Access Compliance Report

Public Rights-of-Way

(Curb Ramps)

Intersection ID: 14315	Main Street: DRIFTWOOD_DR	Cross Street: ROSEHAVEN_DR	Location: NE
ADA ID: 945A76CF45F2	Ramp Type: PerpDiag	Initial Pass/Fail: Fail	Overall Compliance: No
		Severity Score: 8.75

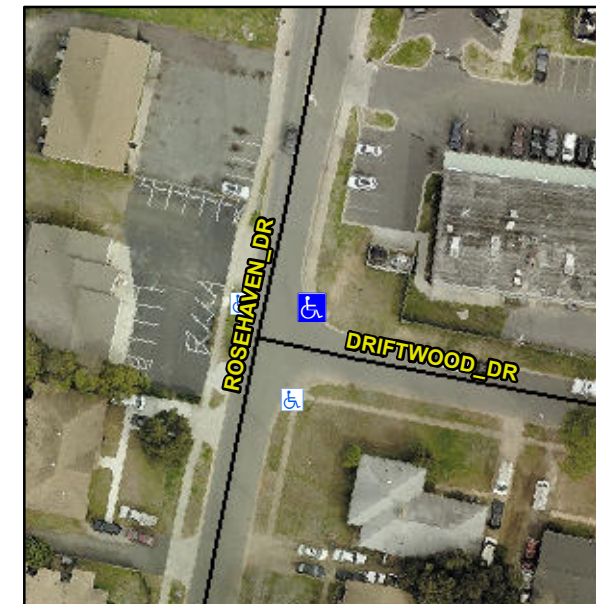
Not Found, R304.5.1

Remove & Replace Curb Ramp With Two New Directional Ramps or Equivalent.
